Access Compliance Report

Public Rights-of-Way

(Curb Ramps)

Intersection ID: 10036062	Main Street: RIVERGATE_PY	Cross Street: N/A	Location: SE
ADA ID: CFAED07A3EB1	Ramp Type: BlendTrans1	Initial Pass/Fail: Fail	Overall Compliance: No
Severity Score: 12.5			
Codes/Mitigation Info/Possible Solution		Field Measurements/Component Compliance

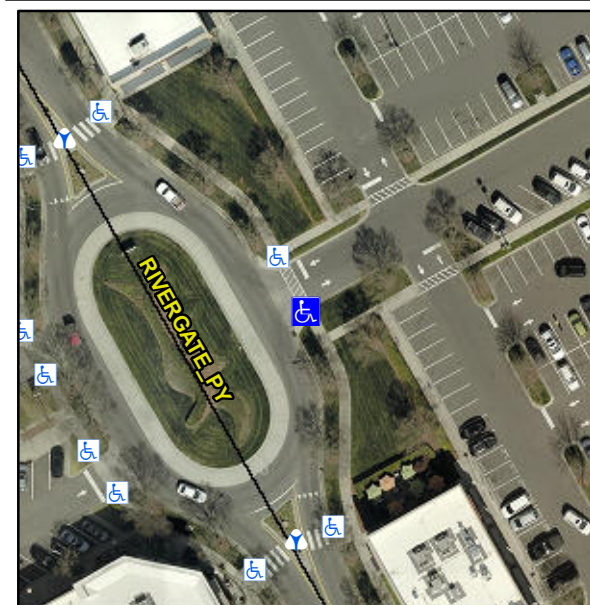
Not Found, R304.5.3

Compliance	Description	Data	Compliance	Description	Data
N/A	Ramp Length (in)	59.0	Yes	BlendTrans Slope (%)	3.0
Yes	Ramp Width (in)	72.0	No	BlendTrans XSlope (%)	5.1
N/A	Flare Type LT	N/A	N/A	Flare Type RT	N/A
N/A	Flare Slope LT (%)	N/A	N/A	Flare Slope RT (%)	N/A
N/A	Flare Traversable LT?	N/A	N/A	Flare Traversable RT?	N/A
N/A	Landing Length (in)	N/A	N/A	DWS Provided?	N/A
N/A	Landing Width (in)	N/A	N/A	DWS Contrast?	N/A
N/A	Landing Slope (%)	N/A	N/A	DWS Length (in)	N/A
N/A	Landing X Slope (%)	N/A	N/A	DWS Full Width?	N/A
N/A	Landing Curb? (Y/N)	N/A	N/A	DWS Offset (in)	N/A
N/A	Shared Landing?	N/A			
N/A	Gutter Ponding?	N/A	N/A	Gutter Slope (%)	N/A
N/A	Gutter Lip Ht (in)	N/A	N/A	Gutter X Slope (%)	N/A
N/A	Painted X Walk1?	Yes	N/A	Painted X Walk2?	N/A
	X Walk 1 Direction	To NW		X Walk 2 Direction	N/A
	X Walk 1 Width (in)	63.0		X Walk 2 Width (in)	N/A
	X Walk 1 Slope (%)	1.9		X Walk 2 Slope (%)	N/A
	X Walk 1 X Slope (%)	0.8		X Walk 2 X Slope (%)	N/A

N/A	Ramp inside XWalk1?	Yes	N/A	Ramp inside XWalk2?	N/A
	Road Slope (%)	0.8		Clear Space?	N/A
	Road X Slope (%)	1.9	N/A	Clear Space to XWalk (in)	N/A
N/A	Any Obstructions?	N/A	N/A	Storm Grate/Utility Hazard?	N/A
	Obstruction Type			Storm Grate/Utility Type	
		N/A			N/A
			Yes	Surface Condition? (G/P)	Good
			No	Curb Slope (%)	21.9

Remove & Replace Curb Ramp With Two New Directional Ramps or Equivalent.
